REMARKS

The invention includes an in-line expansion tank. As fluid traverses a pipe within the tank, it may pass into and displace a diaphragm disposed outside of the pipe if the fluid pressure is greater than a tank pressure pushing the diaphragm against the pipe. When the fluid pressure decreases, the fluid passes from the diaphragm back into the pipe.

AMENDMENTS TO THE DRAWINGS:

FIG.1A

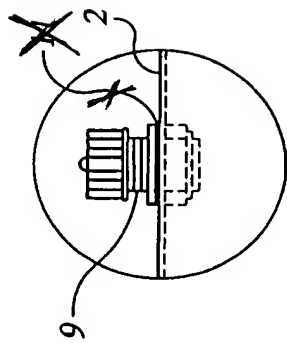
The drawings are objected to for various informalities. As noted above, Figure 1A has been amended to remove reference sign 11. The Examiner also states that the subject matter of claim 5 is not shown in the claims. Applicant respectfully disagrees. The recitations of claim 5 are illustrated in Figures 1 and 2, which show a diaphragm 6 having two ends. As shown, the ends of the diaphragm have a smaller cross-sectional area than a middle portion of the diaphragm, as recited in claim 5. Applicant submits that the figures meet the requirements of 37 C.F.R. §1.84.

An attached replacement drawing sheet(s) and an annotated sheet(s) showing changes to the drawings are attached to this Response as an Appendix. These replacement sheets comprise amendments to Figure 1A. Specifically, reference sign 11 has been removed from the figure. These amendments correct the informalities noted in the objections to the drawings by the Examiner. Accordingly, Applicants respectfully request that all objections to the drawings be withdrawn.
